Subdivision Authority

File No. LDA08-0069

RE: Tentative plan of subdivision to create 204 low density residential lots and two municipal reserve lots from portions of SW-22-51-24-4 and Plan 7920978 Lot 1 located east of 88 Street SW and north of 25 Avenue SW; **SUMMERSIDE**

SUBDIVISION CONDITIONS OF APPROVAL MAP

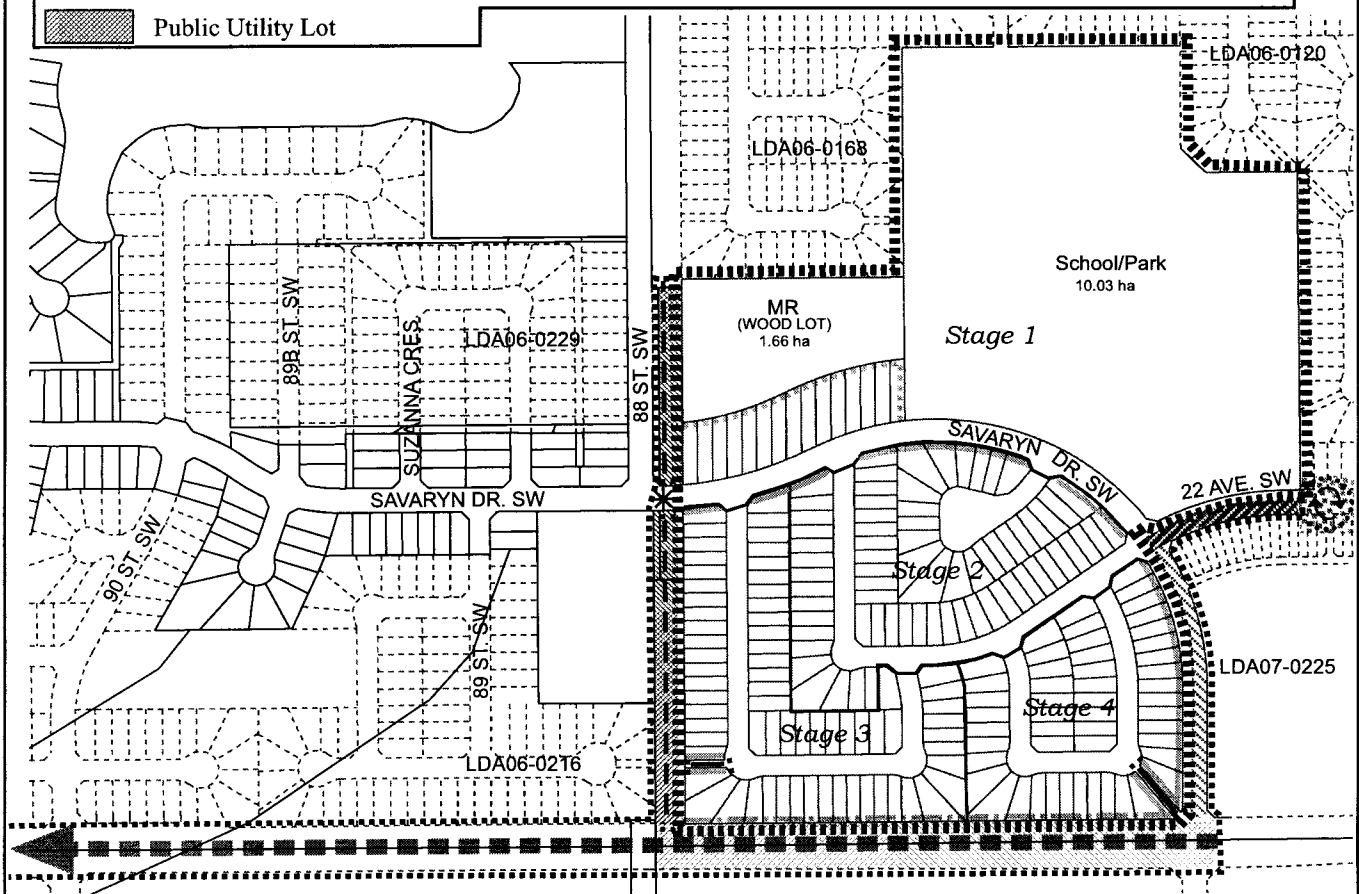
1. that the owner dedicate Municipal Reserve as 1.66 and 10.03 ha parcels pursuant to Section 666 of the Municipal Government Act as shown on the "Conditions of Approval" map, Enclosure I;

5. that the subdivision boundary be amended to include the road right-of-way dedication and that portion of the power line right-of-way that abuts this subdivision, as shown on the "Conditions of Approval" map, Enclosure I;

6. that the property line and road right-of-way dedication conform to an approved Concept Plan or to the satisfaction of the City of Edmonton for 25 Avenue SW from Savaryn Drive to the transmission line right-of-way, as shown on the "Conditions of Approval" map, Enclosure I;

8. that the owner be permitted to register this plan of subdivision in stages, as shown on the "Conditions of Approval" map, Enclosure I, at the discretion of the Chief Subdivision Officer, having regard to the provision of roadways and the logical extension of services;

6. that the owner construct 22 Avenue SW from Savaryn Drive to the east edge of the school/park site (with a mono-walk with straight faced curb and gutter along Savaryn Drive/22 Avenue adjacent to the school/park area to accommodate pick-up/drop-off activity) with development of Stage 1, as shown on the "Conditions of Approval" map, Enclosure I;

7. that the owner construct a 3 m asphalt multi-use trail with a dividing yellow centerline and "Shared Use" signage from north of the MR parcel to Savaryn Drive with development of Stage 1, as shown on the "Conditions of Approval" map, Enclosure I;

8. that the owner construct with Stage 1, a marked crosswalk with curb extensions, ramps and pedestrian signage, as shown on the "Conditions of Approval" map, Enclosure I;

9. that the owner construct Savaryn Drive from 22 Avenue SW to 25 Avenue SW and two lanes of 25 Avenue to a divided urban arterial roadway standard from Savaryn Drive to the urbanized section of 25 Avenue SW to the west, with the development of Stage 3 (the arterial road must be operational and open to traffic, with all lighting installed and energized no later than 3 years after the Servicing

Agreement for Stage 3 is signed), as shown on the "Conditions of Approval" map, Enclosure I;

10. that the owner construct a 3 m asphalt multi-use trail with a dividing yellow centerline and "Shared Use" signage from Savaryn Drive to 25 Avenue SW with development of Stage 3, as shown on the "Conditions of Approval" map, Enclosure I;

11. that the owner construct walkways with 1.5 m concrete sidewalks with bollards, lighting and 1.8 m uniform fencing to be provided within residential property lines, as shown on the "Conditions of Approval" map, Enclosure I;

12. that the owner construct an offset 17 m radius asphalt temporary transit turnaround with bollards with Stage 1, as shown on the "Conditions of Approval" map, Enclosure I. The temporary turnaround will be required at FAC or earlier, at the discretion and direction of the Transportation Department;

16. that the owner construct all fences positioned wholly on privately-owned lands to the satisfaction of the Asset Management and Public Works Department in the location as shown on the "Conditions of Approval" map, Enclosure I.

- Property line and road dedication to conform to approved concept plan
- Construct 25 Ave. from Savaryn Dr. to urbanized arterial roadway section west of the subdivision with Stage 3
- Construct Savaryn Dr. from 22 Ave. to 25 Ave. with Stage 3
- Construct 22 Ave. from Savaryn Drive to eastern boundary of park site in Stage 1
- 17.0m Temporary asphalt turnaround
- Curb extensions, ramps, marked crosswalk and pedestrian signage
